### APPEAL SUMMARY

**Appeal ID:** 19041

**Project Address:** 631 SE Taylor St

**Building/Business Name:** The Rose Apartments

GA3

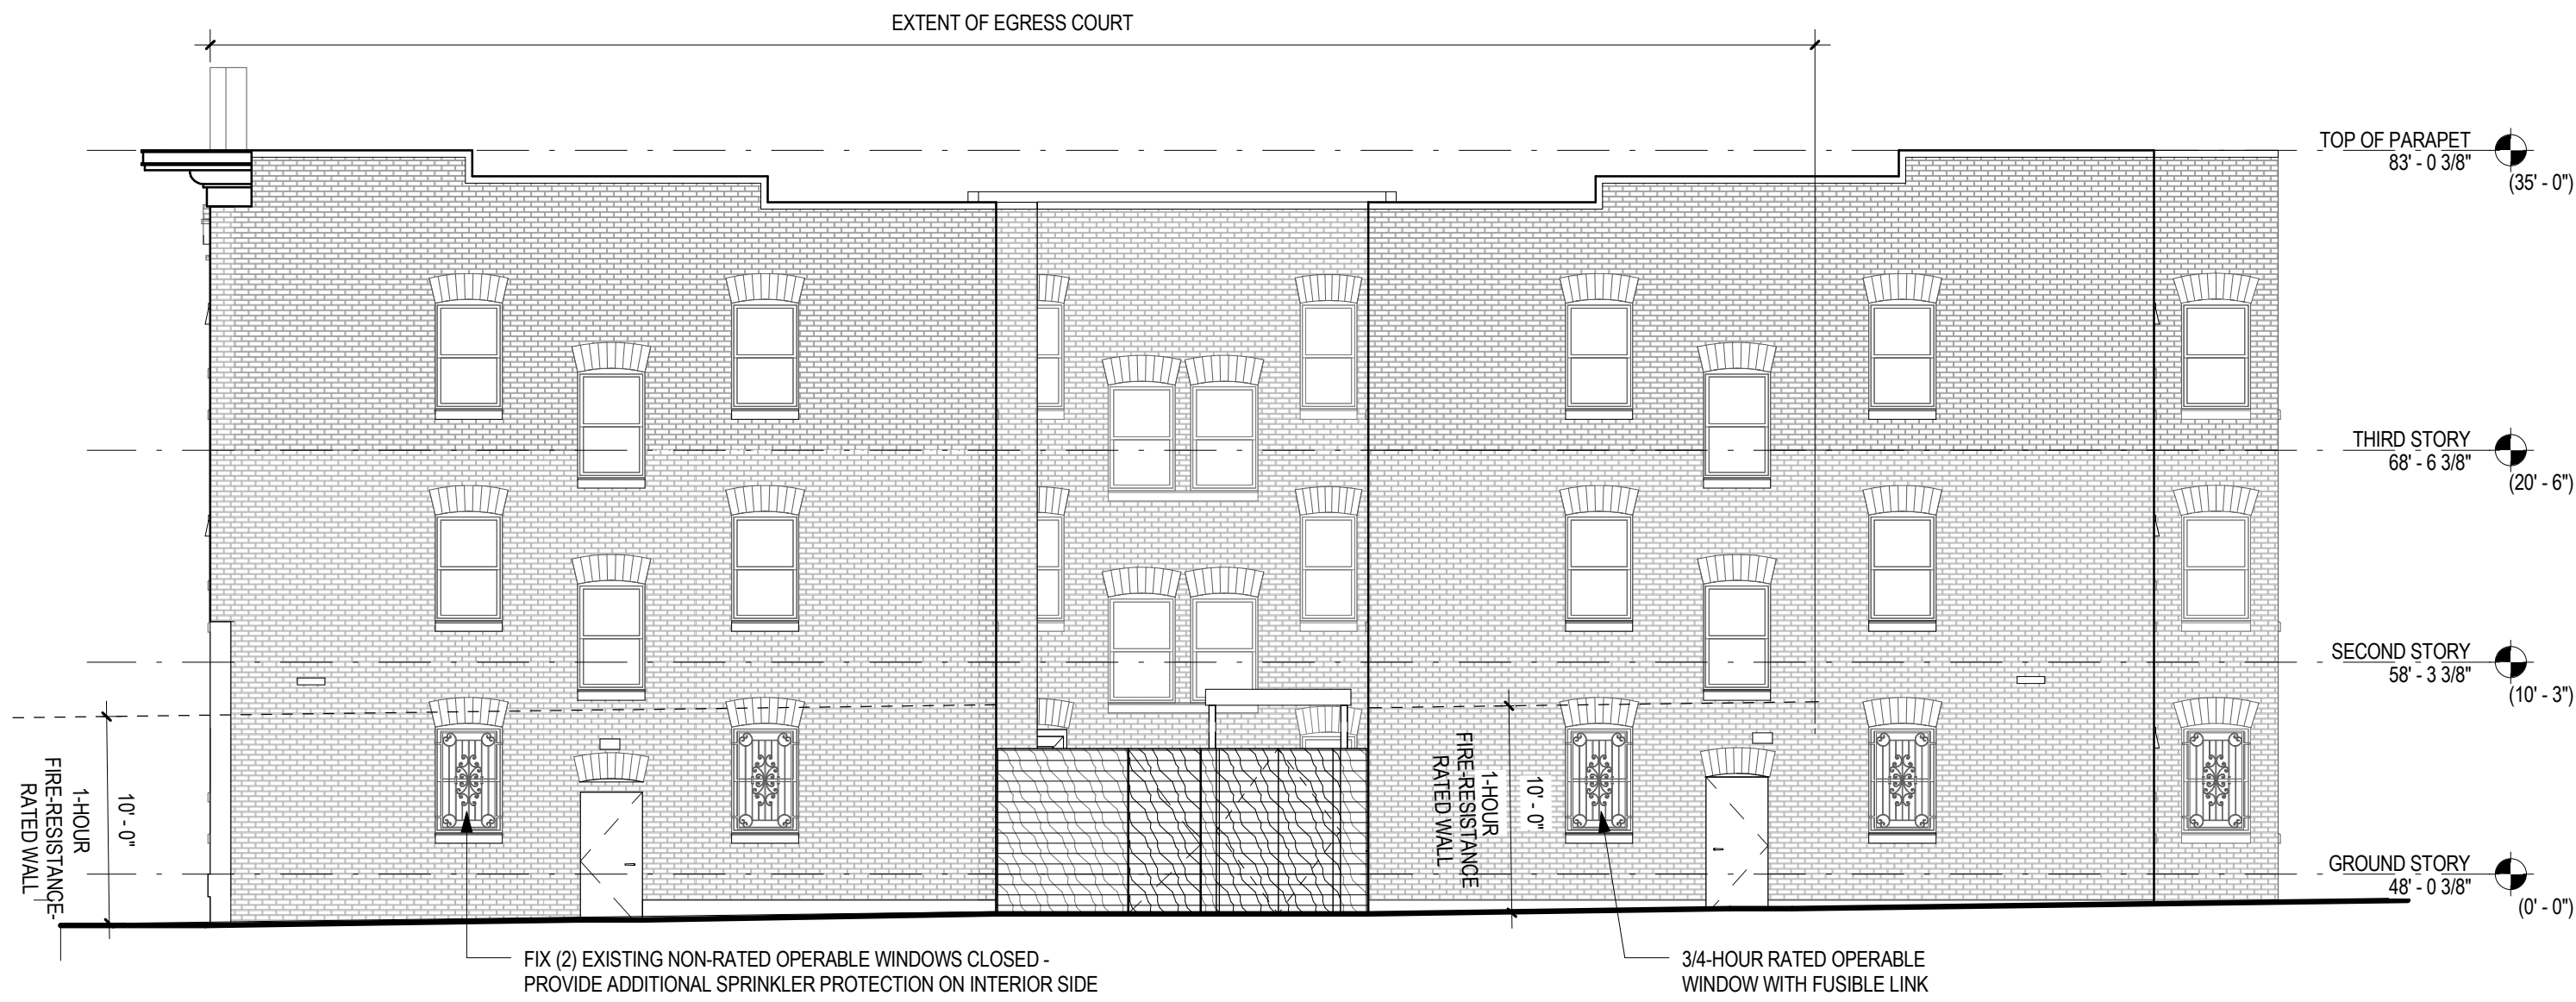
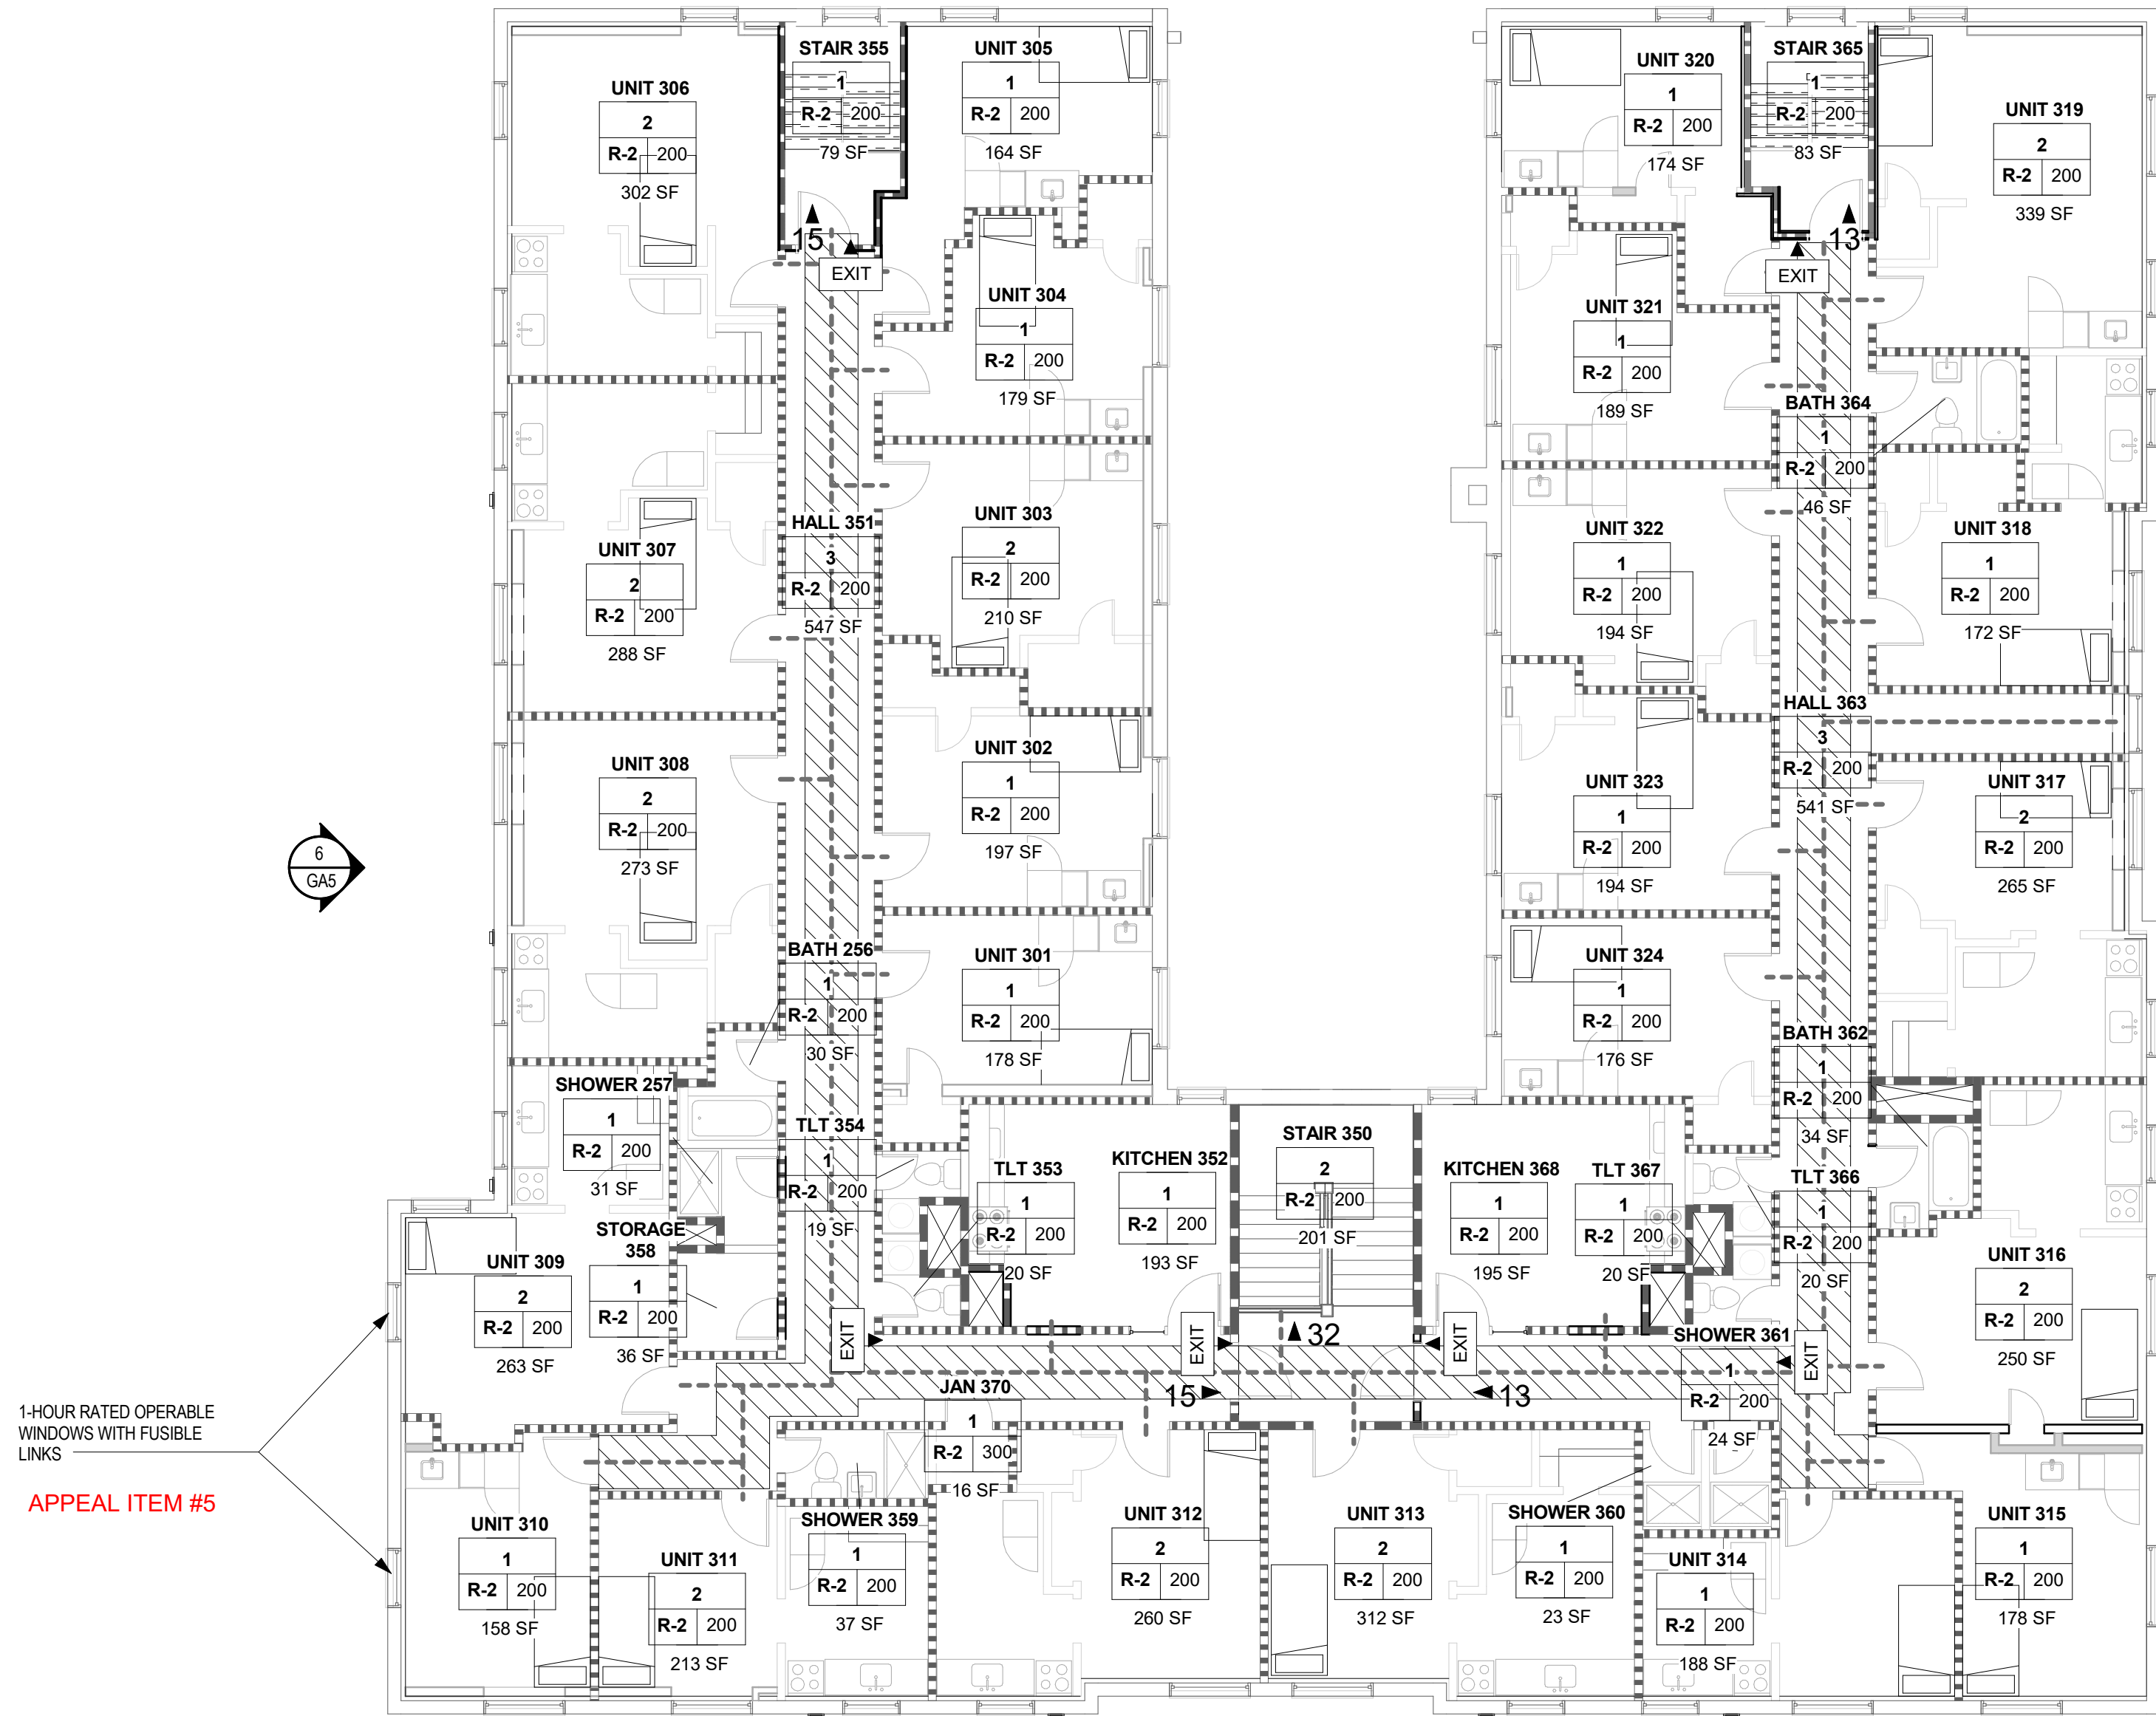
There is one existing ground story non-rated operable window along the western portion of the egress court (Unit 105). This window was approved by Appeal #6358. This window will be replaced with a UL listed ¾-hour fire-rated operable window with a fusible link that closes the window in the event of a fire. There are two existing ground story non-rated operable windows along the eastern portion of the egress court (Kitchen 124 and Food Pantry 123). These windows were approved by Appeal #6358. These windows will remain and be fixed in place, with additional sprinkler protection provided on the interior side. See Sheets GA2 and GA3.

<b>Code Section</b>	Table 705.8 Allowable Openings Based on Fire Separation Distance
<b>Requires</b>	Unprotected openings less than 3' from a property line are not permitted.
<b>Proposed Design</b>	<p>ORIGINAL APPEAL TEXT: The six unprotected operable windows at the west property line shall remain. The building shall be equipped with a full NFPA 13 sprinkler system throughout. See GA2 and GA3.</p> <p>RECONSIDERATION TEXT: The six unprotected operable windows at the west property line shall be replaced with UL listed 1-hour fire-rated operable windows with a fusible links that close the windows in the event of a fire. The building shall be equipped with a full NFPA 13 sprinkler system throughout. See GA2, GA3 and GA5.</p>

**1. Type 13 water curtain sprinkler protection at non-fire rated openings in exterior walls of egress court less than 10' in width: Granted provided windows are non-operable and sprinklers are spaced not more than 6 feet apart and placed a minimum of 6 inches and a maximum of 12 inches from the opening(s) and a maximum of 12 inches below the ceiling. Sprinklers are to be installed on the occupied side of the openings. A separate permit from the Fire Marshal's Office is required.**

**4. Proposed UL listed 1 hour fire rated operable windows with self closing mechanisms at property line: Granted as proposed.**
